Response to Referee #2 Comments

Figure 1: Structure representation of the actual model (Act_) and the comparative analysis model (Comp_). (a) Act_SEL and Act_MEL. (b) Act_Sts and Comp_Sts.

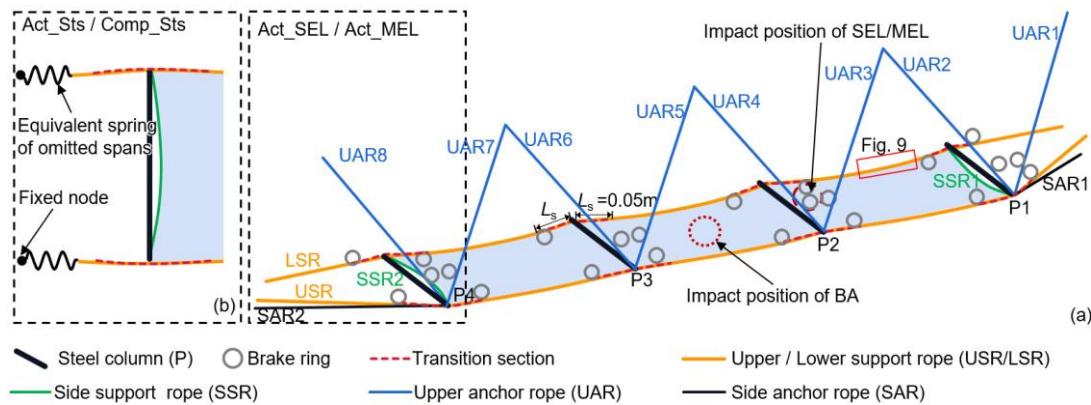
In general in the text the acronyms are note specified please add a figure or a table specifying the meaning of them, otherwise some figures and some text portion are not understandable. Furthermore, it is need a table to specify the model parameter values used in the numerical simulations.

Response: Tow figures and an appendix of abbreviations have been added in order to enhance the understandable of the acronyms and symbols. Furthermore, Table 3 has been updated to show the parameter values used in the numerical simulations.
